North Strathfield Station Upgrade

Determination Report

Figure 2: Revised site compound area

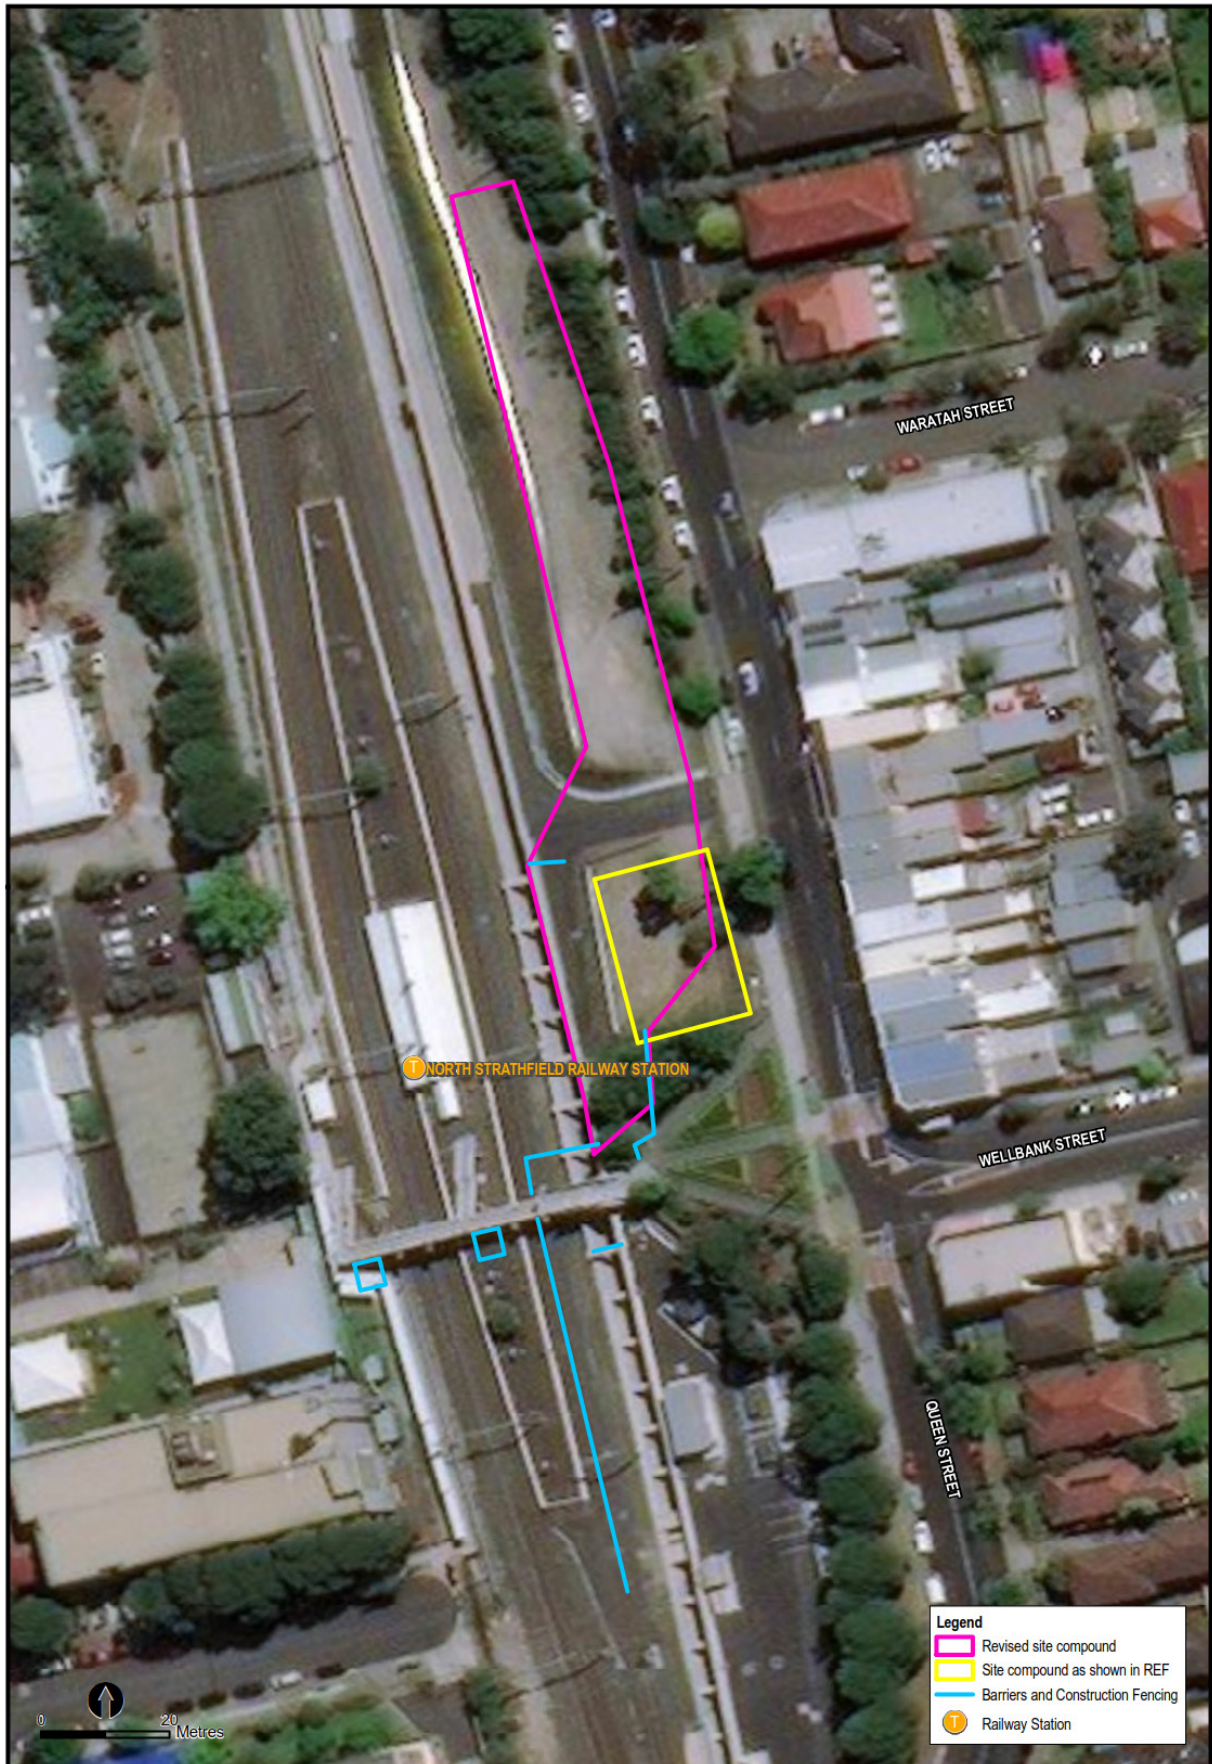
As a result of the submissions received during the public display, the following design changes have been made to the Proposed Activity. The design changes to the Proposed Activity are summarised in Table 2. Additionally, it was identified that modifications to the site compound were required (Figure 2), whilst footpath widening on Queen Street was not required.

As a result of ongoing design development during the public display period, it was identified that modifications to the proposed site compound area were required to accommodate the laydown requirements and machinery.

The extended area of the proposed site compound area (Figure 2) would continue to be confined to hardstand areas previously used as a compound for the NSRU works and would not require any additional vegetation clearing. The access point for construction vehicles to the site compound area would also remain unchanged. The northern end of the revised compound would likely be utilised for storage and laydown of materials. This area would continue to be screened by existing vegetation along Queen Street).
